Access Compliance Report

Public Rights-of-Way

Intersection ID: 10319	Main Street: BACON_AV	Cross Street: ROZZELLES_FERRY_RD	Location: SW
ADA ID: 3AC49AEE6B87	Ramp Type: BlendTrans2	Initial Pass/Fail: Fail	Overall Compliance: No
		Severity Score: 60

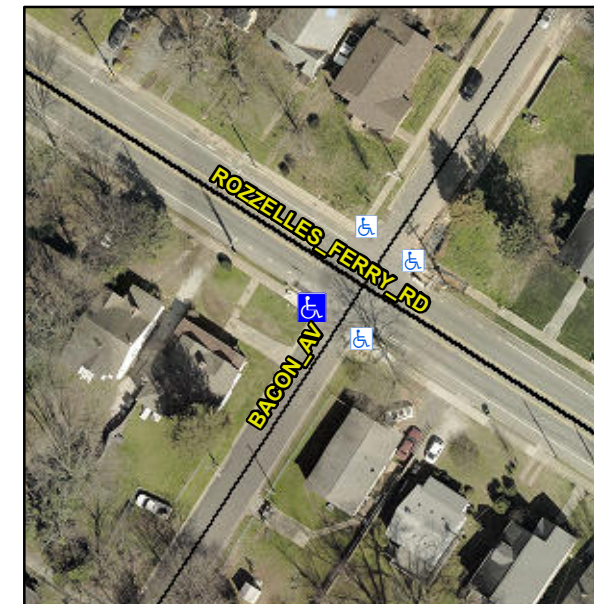
Not Found, R304.5.1, R304.5.3

Compliance	Description	Data	Compliance	Description	Data
N/A	Ramp Length (in)	54.0	Yes	BlendTrans Slope (%)	2.0
No	Ramp Width (in)	25.0	No	BlendTrans XSlope (%)	7.8
N/A	Flare Type LT	N/A	N/A	Flare Type RT	N/A
N/A	Flare Slope LT (%)	N/A	N/A	Flare Slope RT (%)	N/A
N/A	Flare Traversable LT?	N/A	N/A	Flare Traversable RT?	N/A
N/A	Landing Length (in)	N/A	N/A	DWS Provided?	N/A
N/A	Landing Width (in)	N/A	N/A	DWS Contrast?	N/A
N/A	Landing Slope (%)	N/A	N/A	DWS Length (in)	N/A
N/A	Landing X Slope (%)	N/A	N/A	DWS Full Width?	N/A
N/A	Landing Curb? (Y/N)	N/A	N/A	DWS Offset (in)	N/A
N/A	Shared Landing?	N/A			
N/A	Gutter Ponding?	N/A	N/A	Gutter Slope (%)	N/A
N/A	Gutter Lip Ht (in)	N/A	N/A	Gutter X Slope (%)	N/A
N/A	Painted X Walk1?	No	N/A	Painted X Walk2?	No
	X Walk 1 Direction	To SE		X Walk 2 Direction	To NE
	X Walk 1 Width (in)	N/A		X Walk 2 Width (in)	N/A
	X Walk 1 Slope (%)	6.3		X Walk 2 Slope (%)	5.7
	X Walk 1 X Slope (%)	2.0		X Walk 2 X Slope (%)	6.0

N/A	Ramp inside XWalk1?	N/A	N/A	Ramp inside XWalk2?	N/A
	Road Slope (%)	6.8		Clear Space?	N/A
	Road X Slope (%)	8.3	N/A	Clear Space to XWalk (in)	N/A
N/A	Any Obstructions?	N/A	N/A	Storm Grate/Utility Hazard?	N/A
	Obstruction Type			Storm Grate/Utility Type	
		N/A			N/A
			Yes	Surface Condition? (G/P)	Good
			No	Curb Slope (%)	23.5

Remove & Replace Curb Ramp With Two New Directional Ramps or Equivalent.
